THE VILLAGE AT TOTEM LAKE: MIXED USED DEVELOPMENT / KIRKLAND, WASHINGTON
DESIGN REVIEW BOARD, MINOR MODIFICATIONS

BUILDING A - ROOF PLAN
PRESENTED 01/04/2016

BUILDING B - NEW ELEVATED VIEW (65' ABOVE FINISH GRADE @ BUILDING B)' FROM NORTHWEST CORNER

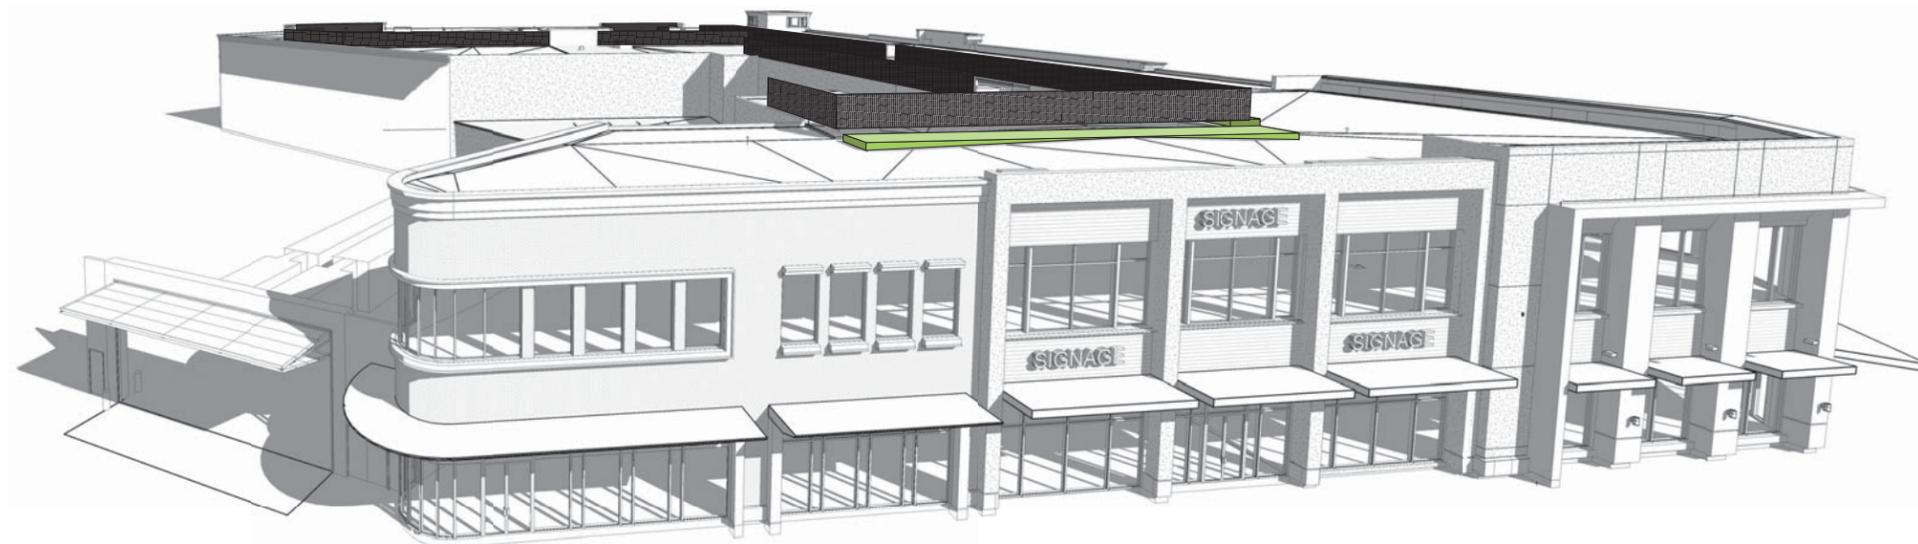
- 1. ROOFTOP MECHANICAL EQUIPMENT RELOCATED WITHIN DRB DEFINED MECHANICAL ZONE:**
NEEDED FLEXIBILITY FOR FUTURE TENANT HVAC REQUIREMENTS.
- 2. SCREEN LAYOUT MODIFIED:**
INCREASE SCREENING OF MECHANICAL EQUIPMENT FROM RESIDENCES IN BUILDING C AND UPPER MALL.
- 3. GREEN ROOF TRAY SYSTEM ADJUSTED:**
ALIGNED WITH NEW MECHANICAL SCREEN.
- 4. SCREEN MATERIAL & COLOR.**
CORRUGATED METAL PANEL: GREY

BUILDING B - NEW WEST ELEVATION & SOUTHWEST CORNER

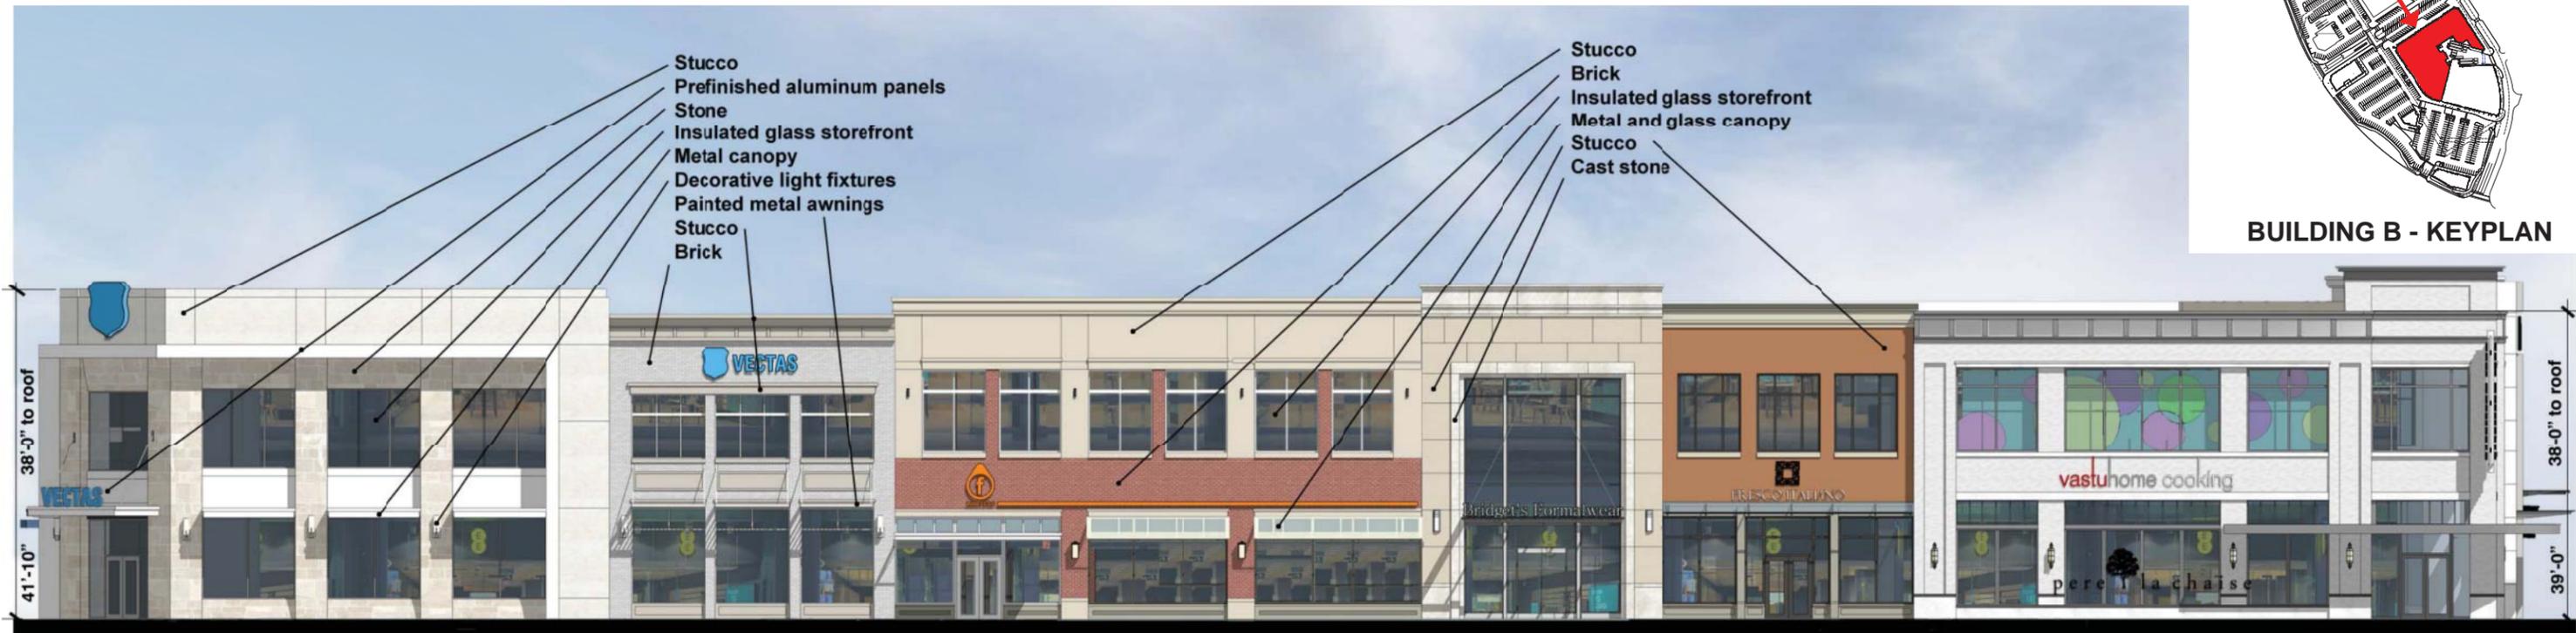
- 1. TOWER ELEMENT CHANGED TO GLAZING:**
DESIGN REFINEMENT
- 2. TOWER ELEMENT PROTRUDES INSTEAD OF RECEEDING:**
DESIGN REFINEMENT
- 3. AUTOMATIC SLIDING ENTRY DOORS MOVED TO SIDE BAYS:**
TO ALLOW FOR CART CORRAL IN CENTER BAY
- 4. BRICK COLOR CHANGED & CANOPY IN CENTER BAY LOWERED:**
TENANT REQUIREMENTS
- 5. MINOR FACADE REVISIONS:**
DESIGN REFINEMENT
- 6. CENTER BAY PROTRUDES FORWARD OF ADJACENT BAYS:**
DESIGN REFINEMENT
- 7. STOREFRONT CHANGED TO OPERABLE:**
TENANT REQUIREMENT

BUILDING B - NEW NORTH ELEVATION

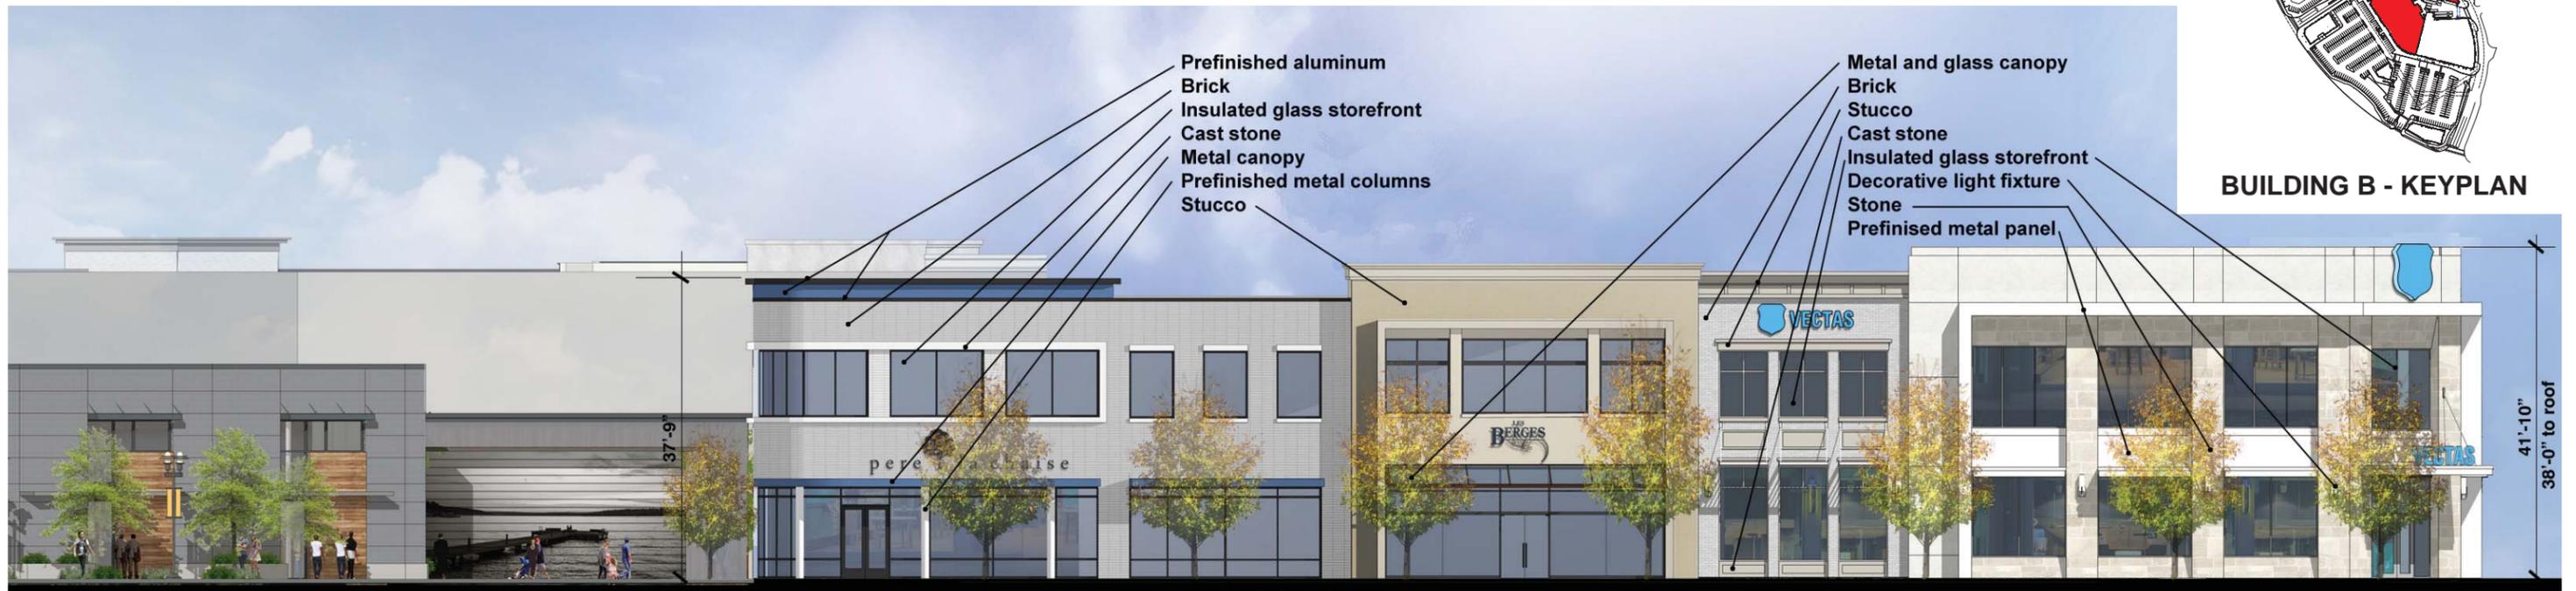
- 1. ALUMINUM SPANDREL CHANGED TO WOOD:**
DESIGN REFINEMENT, ADD WARMTH TO FACADE
- 2. PAINTED METAL AWNING CHANGED TO RIGID CANOPY:**
DESIGN REFINEMENT, ALLOW LIGHT THROUGH TRANSOM
- 3. MATERIAL CHANGE TO BRICK:**
DESIGN REFINEMENT
- 4. FABRIC AWNING:**
DESIGN REFINEMENT
- 5. RIGID CANOPY EXTENDED TO EAST END OF FACADE:**
DESIGN REFINEMENT, FABRIC AWNING NOT COMPATIBLE WITH THIS PORTION OF FACADE.

BUILDING B - CANOPY PLAN
PRESENTED 01/04/2016

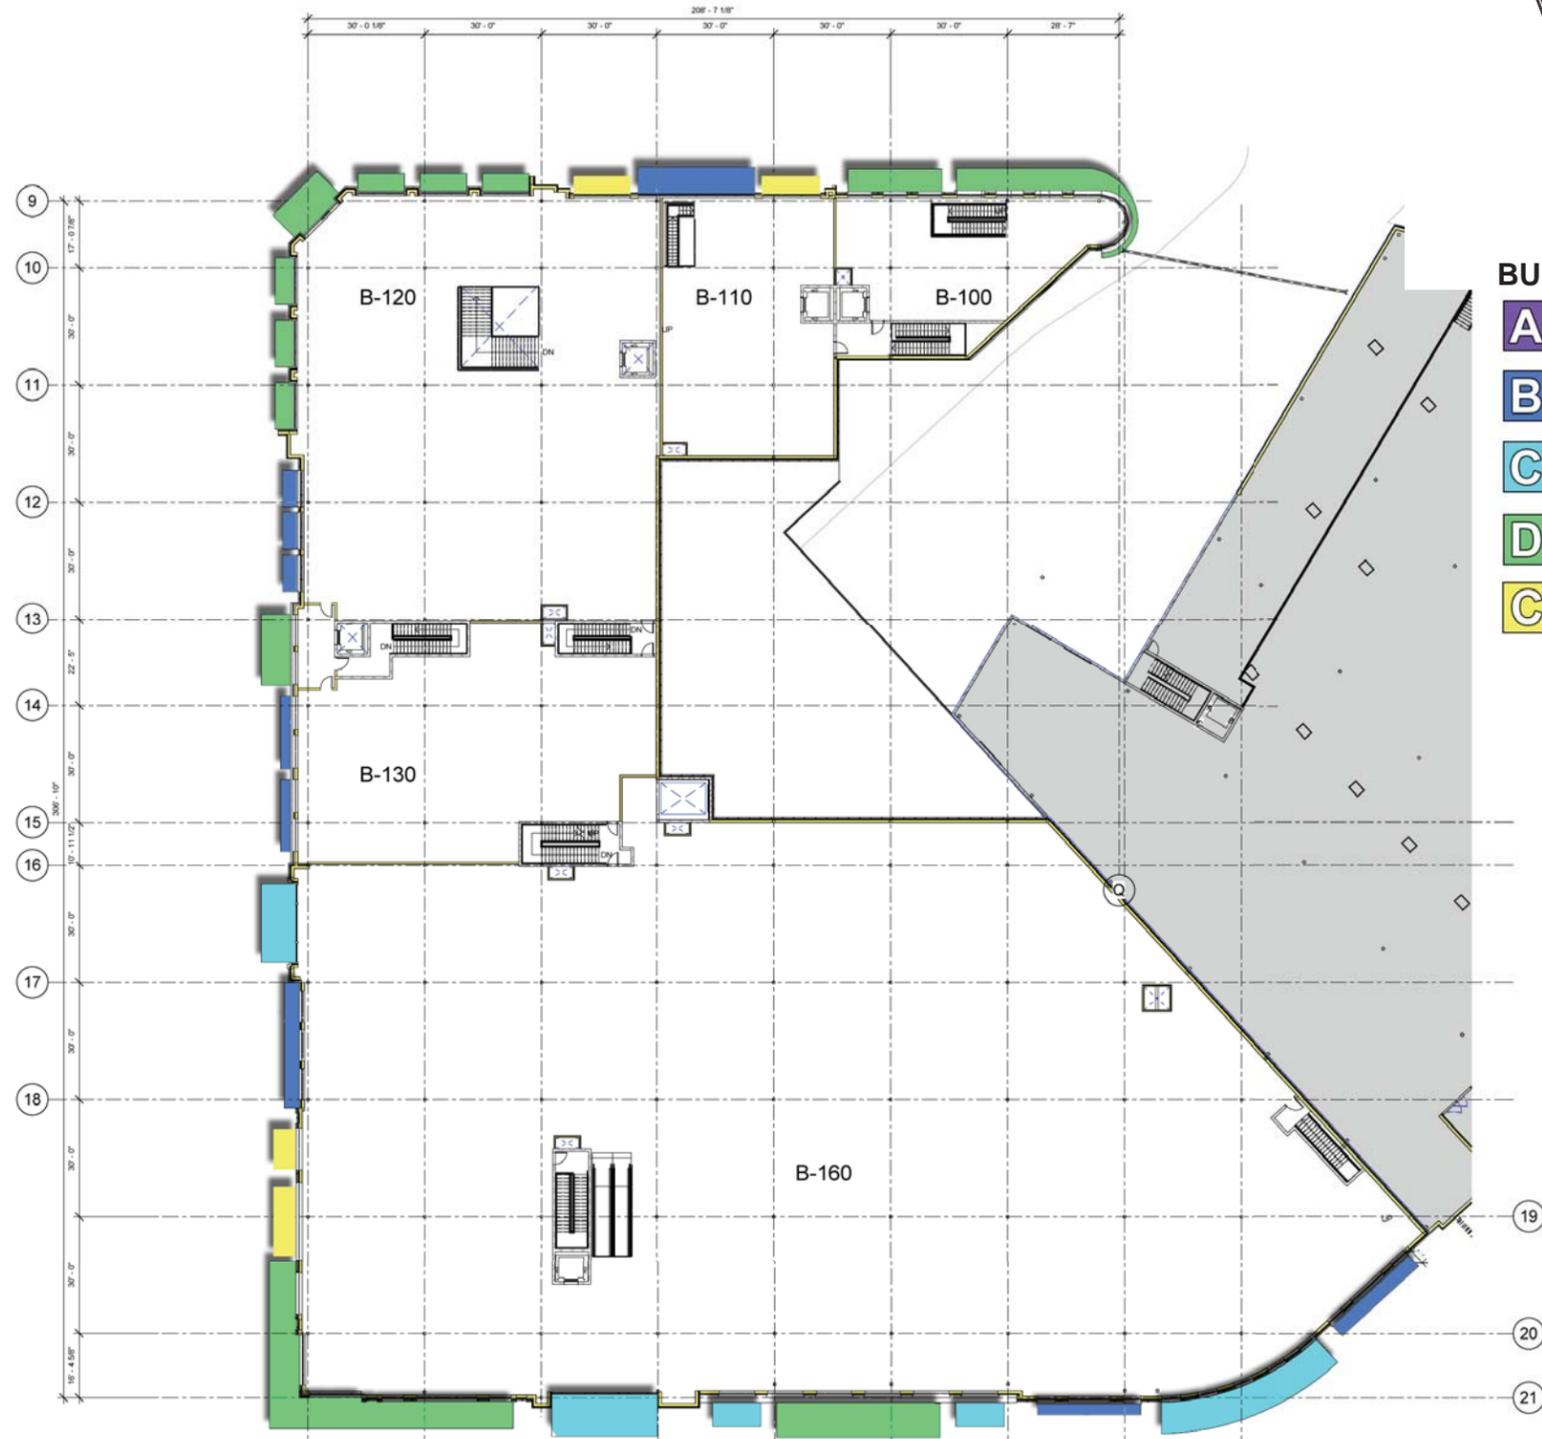
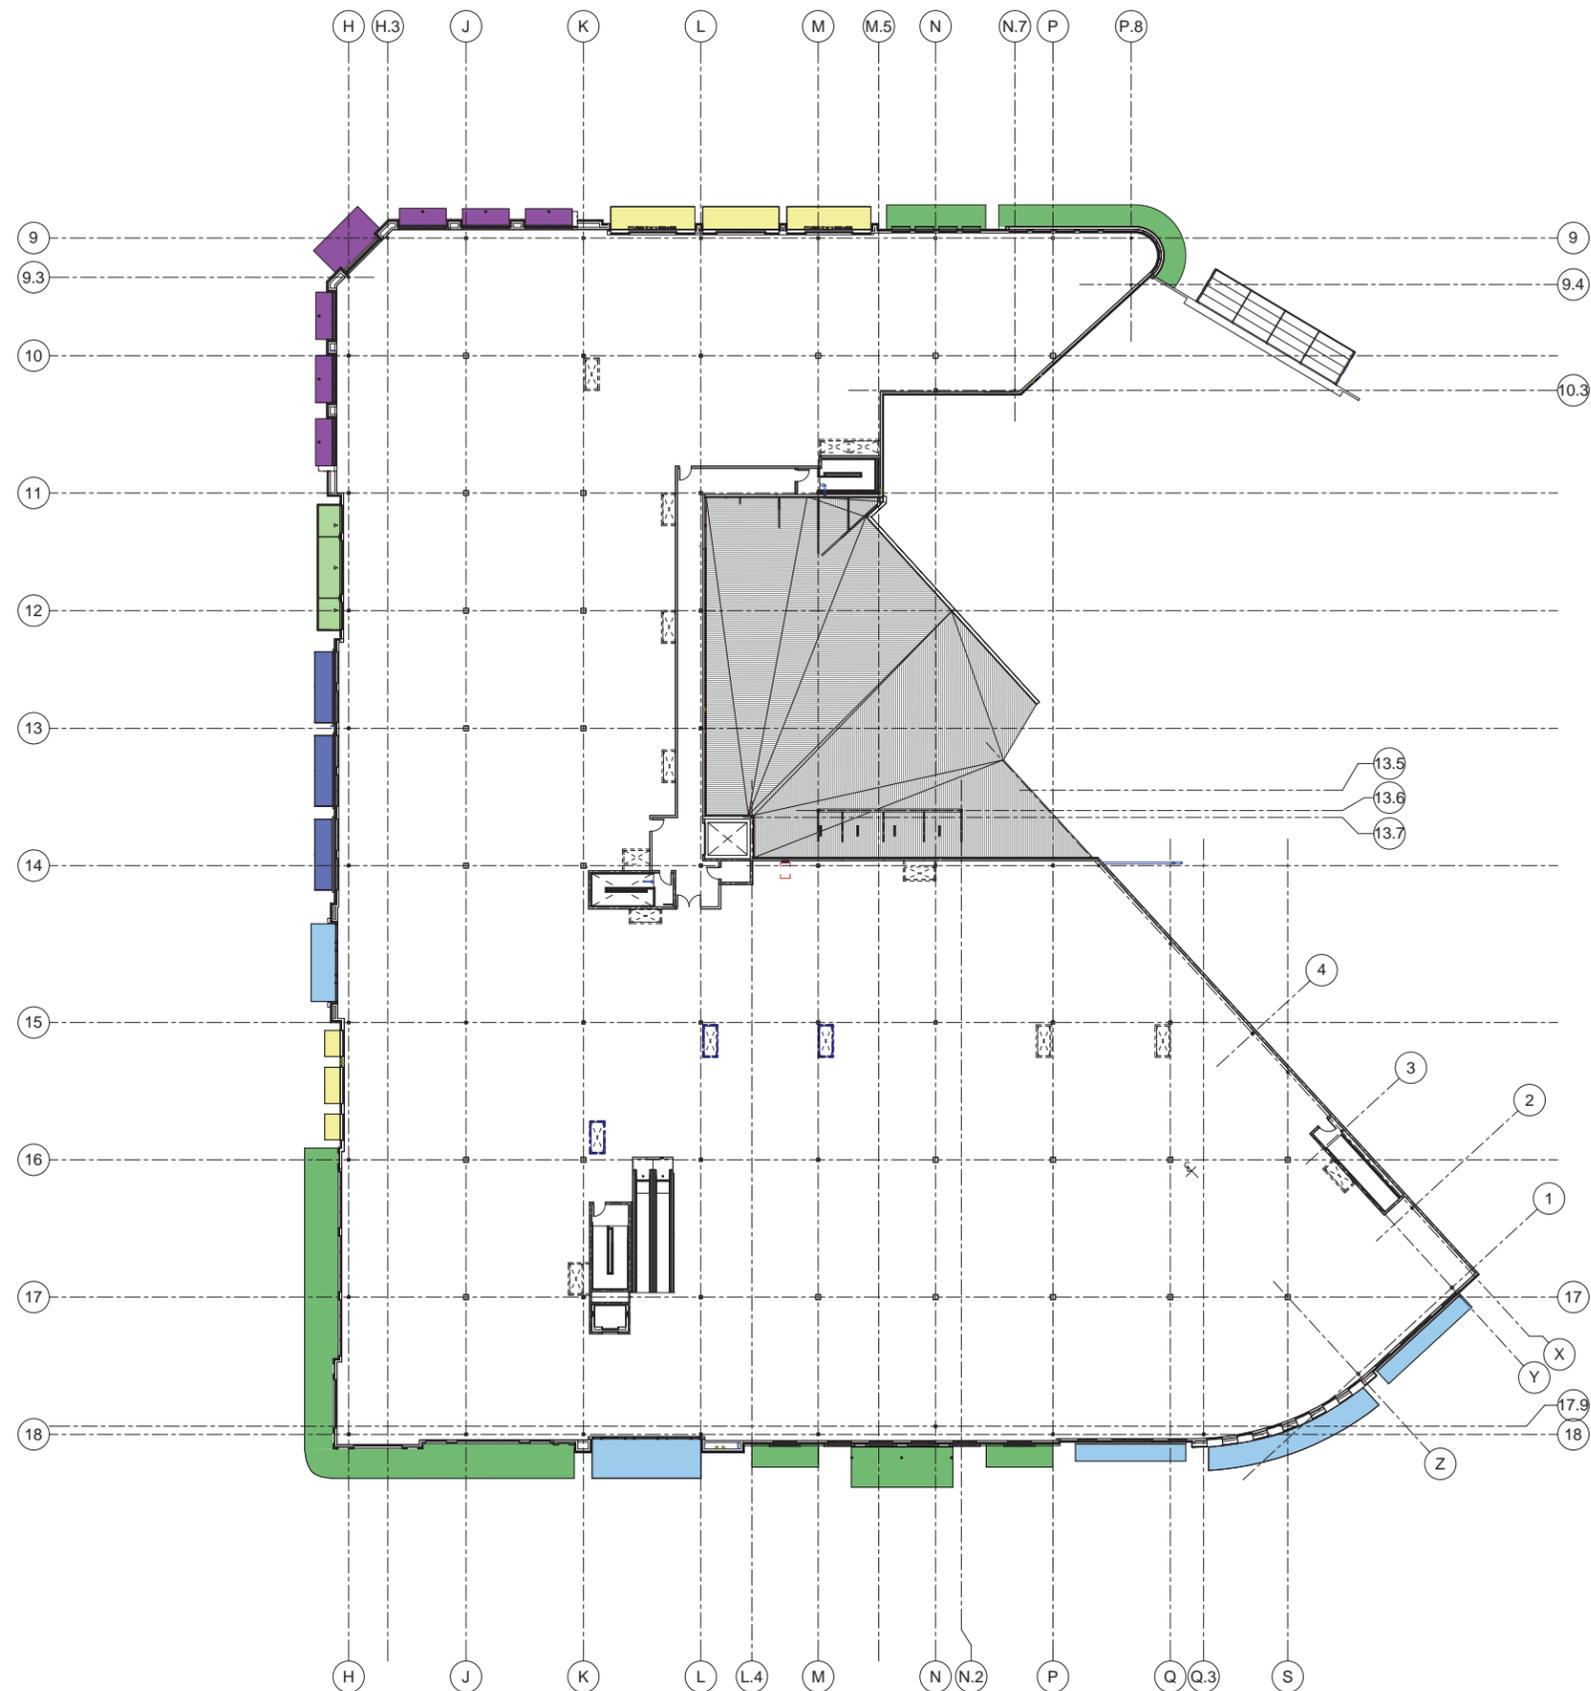
- 1. DESIGN COORDINATION / REFINEMENT

BUILDING M - NEW WEST ELEVATION

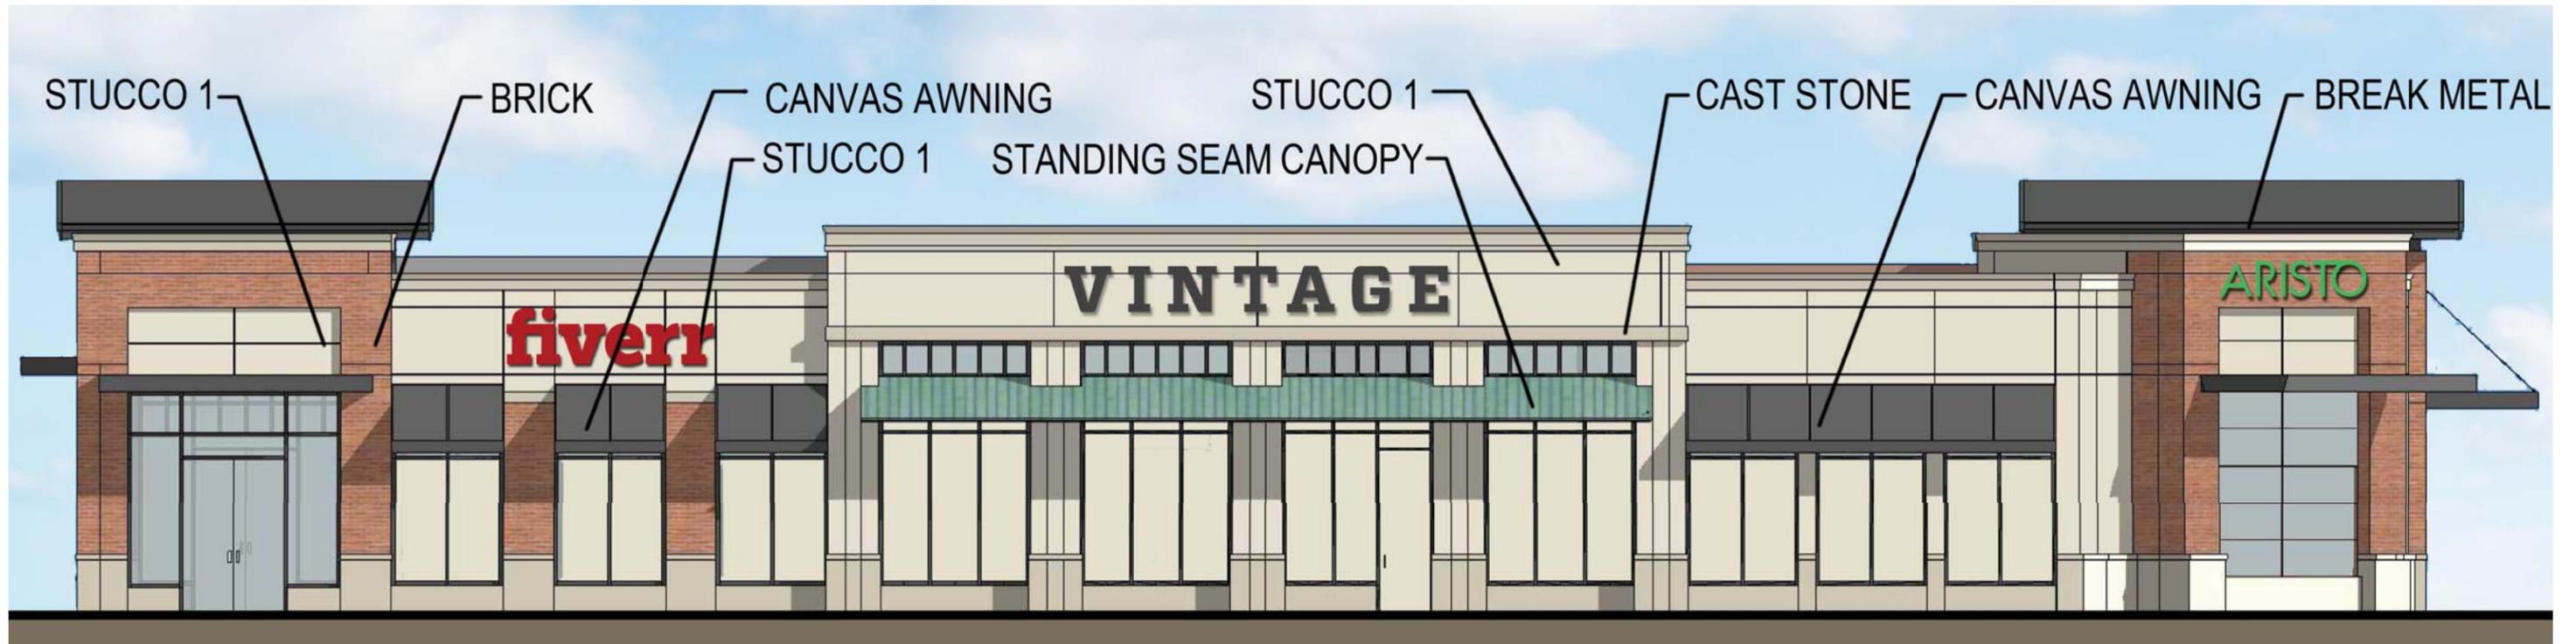
- 1. SLOPED ROOFS AT CORNERS WERE FLATTENED:**
DESIGN REFINEMENT
- 2. GLASS CLERESTORY ADDED AT ANGLED CORNER:**
DESIGN REFINEMENT
- 3. CANOPY ADDED AT PATIO**
PROVIDE SHELTER AT OUTDOOR SEATING AREA
- 4. BUILDING LENGTH SHORTENED APPROXIMATELY 6'-0":**
FOR THE ADDITION OF EXTERIOR SEATING.
